IMPORTANT RECALL INFORMATION #40817

**SUBJECT: RECALL CAMPAIGN #40817
Class C Range and/or Cook Top LP Connection**

**RECALL
BULLETIN:**
#40817

SUBJECT:
Range and/or
Cook Top LP
Gas Connection
Modification

Figure 2

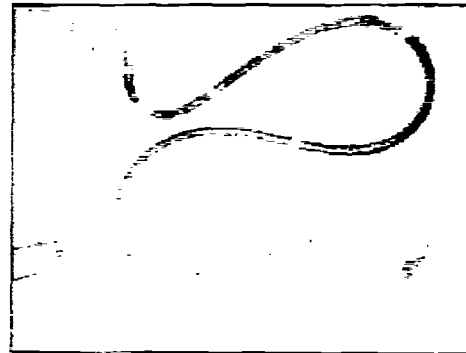
11. Gather the excess LP Gas supply hose in an "S" shape and clamp to the sidewall with 5/8" plastic loop clamps. Secure the LP Gas supply hose to the sidewall using #8 x 1" Phillips, Pan Head sheet metal screws. **Note: Reconfirm the copper tubing extension is away from the edges of the range and/or cook top and centered in the access opening.** See Figure 2.
